Robust training process timing

in support of comment #i-113

Adee Ran, Intel Corp.

Figure 92-X – Training state diagram

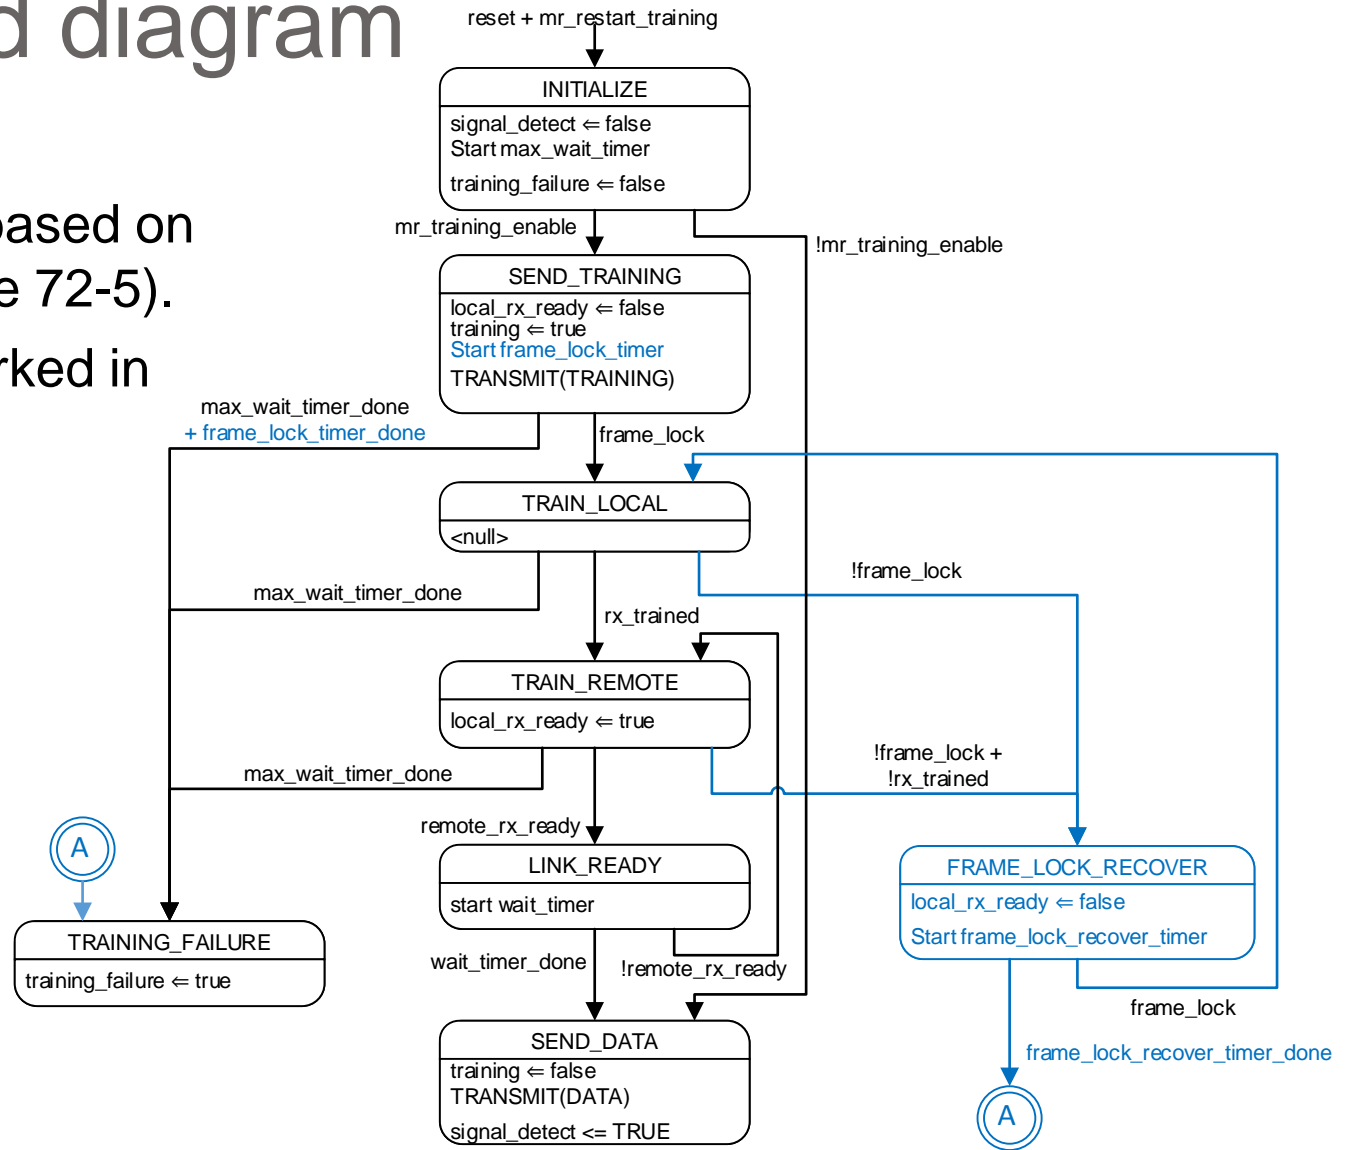
State diagram is based on the original (Figure 72-5).
New behavior marked in blue.

- Implement in subclause 92.7.12:
 - Add two new timers, `frame_lock_timer` and `frame_lock_recover_timer`
 - Use a modified training state diagram as shown.
 - Add explicit statement that the coefficient update field (72.6.10.2.3) is kept unchanged when `frame_lock` is false.
 - Make the 2 ms response time requirement conditional on `frame_lock`.
- Detailed text proposed for subclause 92.7.12 is submitted ([ran_3bj_02_0314.pdf](#)).
- Clause 93 uses an identical function, so refer to Clause 92.
- In clause 94, the changes should be split between 3 subclauses (94.3.10.6.4, 94.3.10.7.5, 94.3.10.11).
 - Refer to figure and timer definition in Clause 92, or repeat.
 - Using same timer value enables >4000 100GBASE-KP4 training frames – still safe.
